23/01762/EREG03

Bath Western Riverside Development Site Phase 2, Windsor Bridge Road, Twerton, Bath, Bath and North East Somerset

Objection

17th July 2023

Image 02 (Fig. 86: View 21 - Park Lane Looking South Proposed & Cumulative AVR2)

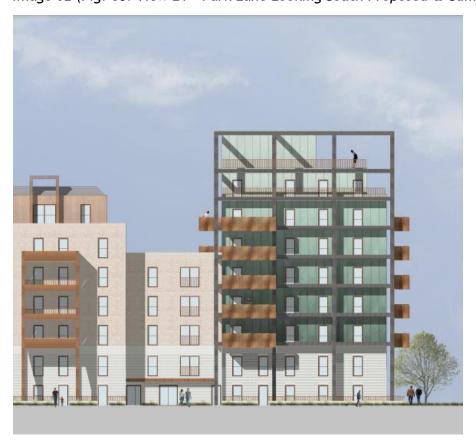
We have strong concerns regarding the proposed 'landmark' building on the north-western corner of Block A, and resulting adverse impact on the landscape setting of the World Heritage Site. Whilst we recognise that the building seeks to draw from the historic presence of Gasholder #5 in landscape views (see Image 01), proposals would introduce a permanent and solid built intervention into long-range views across Bath's townscape. The translucency of the 'filigree' framework would be limited where the framework is infilled with a solid residential block. By contrast, the historic gasholder fluctuated between an opaque and transparent structure (as the balloon filled and emptied), affording views through and out to the green hillside to the south. We additionally question the necessity of the increased height of the proposed framework structure a whole storey above the uppermost residential floor. The height of this structure also appears to exceed the proposed floor-to-floor heights of the residential floors below, resulting in a further unjustified increase in height (see Images 02 & 03).

The north-western block would constitute a 9-storey block of a "max. uninhabited height 50.00m", and as such (accounting for the 0.5 land level difference) would propose an intervention of the same height as Block F on the St William Berkeley site, and would contribute to the cumulative, adverse impact on views across the World Heritage Site and associated harm to the City's landscape setting OUV without justification OR demonstration of sufficient public benefit to outweigh the proposed degree of harm.
